Service Advisory

MTD-043

(Hand Held String Trimmer)

Subject: **MANDATORY REPAIR** - Potential safety concern arising from the potential loss of the shield mounted trimmer blade during operation. The Troy-Bilt string trimmer models listed in "**Models Affected**" within the "**Serial Number Range Affected**" may have suspect shields.

FIGURE 1

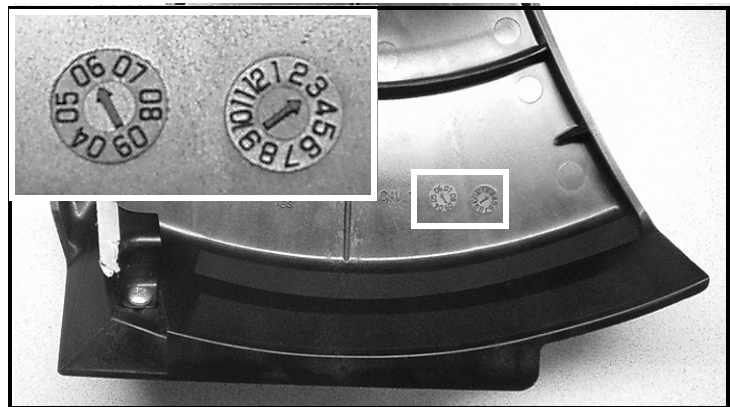
SYMPTOM(S): It has come to our attention that several trimmer blades have broken away from the string trimmer shield during operation. This can lead to personal injury.

- To read the mold date refer to Figure 1. The mold date clock on the left, see inset, is the "mold year" (last two digits of the year). The mold date clock on the right, see inset, is the "mold month".
- Determine the shield's "mold date" by reading the right hand clock then the left hand clock. The mold date for the shield in Figure 1 is "03/06" (March 2006).
- Suspect shields have mold dates of "**12/05**", "**1/06**" and "**2/06**". Determine if the unit has a shield with one of these mold dates.

Service Dealer: 1. All "**Models Affected**" within the "**Serial Number Range Affected**" that are brought into a service dealer for any type of repair or seasonal maintenance must have the shield inspected per "**Shield Assembly Inspection**" below. Suspect shields must be replaced with service kit **753-05375**.

- Replace any suspect shield assembly with Service Kit **753-05375**.
